AMENDMENTS TO THE DRAWINGS

KONDO et al.
Appl. No. 10/816,937
June 14, 2006

ANNOTATED MARKED UP DRAWINGS
FOR SN 10/816,937

FIG. 13B

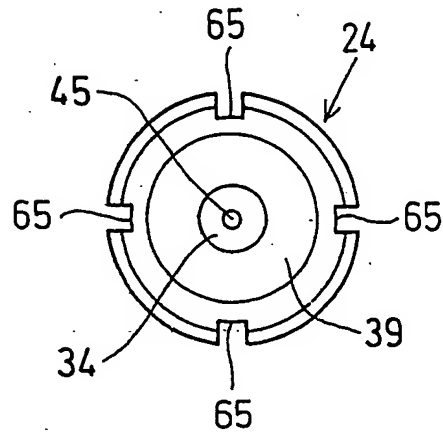
An annotated marked up sheet of drawing is attached showing proposed changes to Fig. 13B. A replacement sheet incorporating such changes is attached as well.

In response to the Examiner's requirement to amend the drawings so as to show the wrench with projections mentioned at claim 12, proposed drawing changes are attached together with a replacement sheet. Accordingly, this issue is now believed to have been obviated.
